IREDELL COUNTY HEALTH DEPARTMENT

IMPROVEMENT PERMIT / AUTHORIZATION TO CONSTRUCT / OPERATION PERMIT / EXISTING SYSTEM INSPECTION

PERMIT# 130385 180380 PIN# ~~4625 [illegible]~~ 4625727432 DATE August 18, 05

SUBDIVISION The Point BLOCK / SECTION 13 LOT 137B LOT AREA 1.021 Ac SITE CLASS. PS DESIGN FLOW 450 gpd L.T.A. - R. e 2

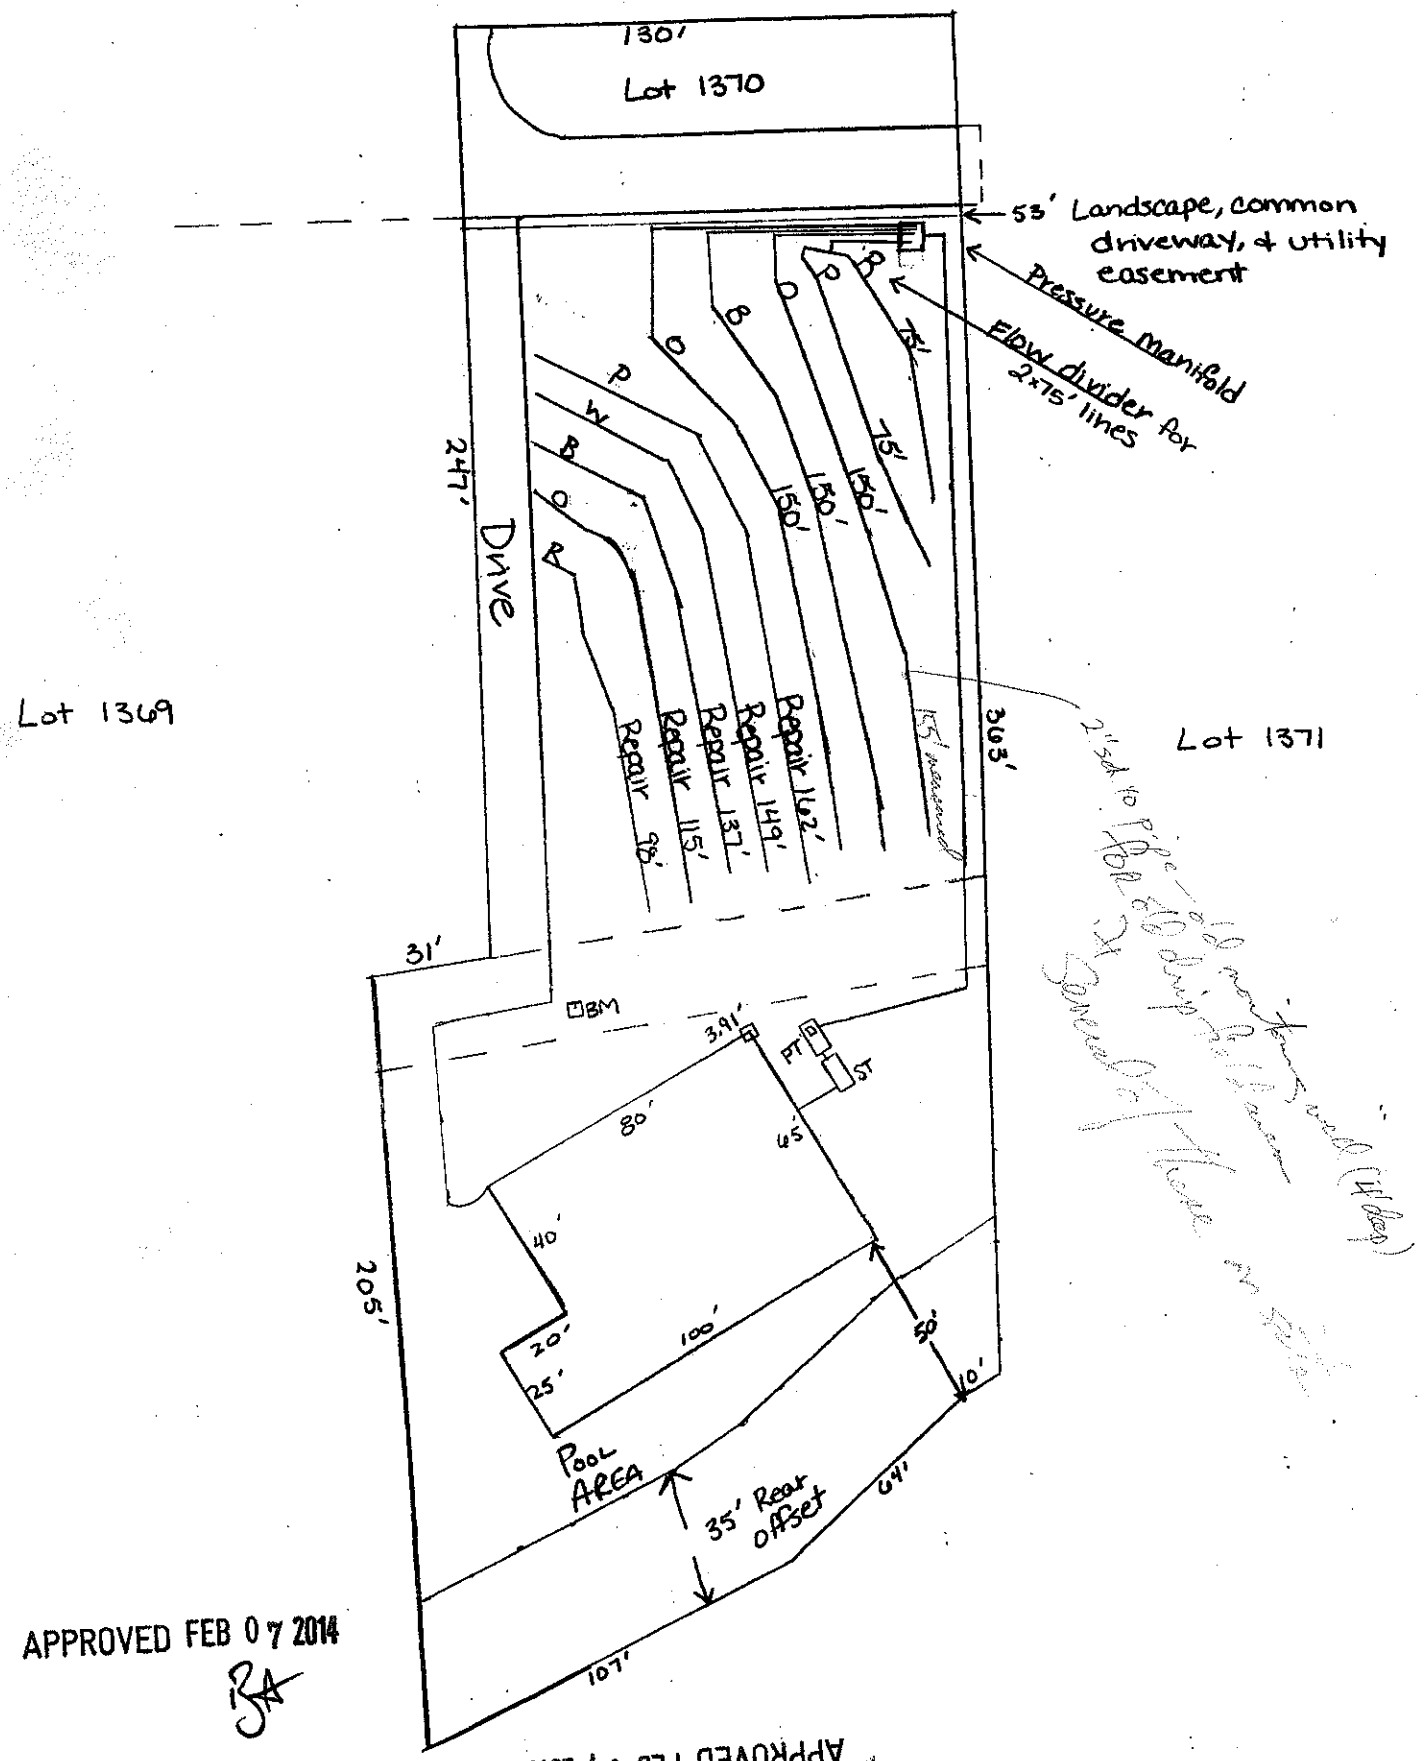
The proposed / existing Pool addition does not appear to impact the existing septic system.

**NOTE: MUST BE MIN 15' FROM SEPTIC
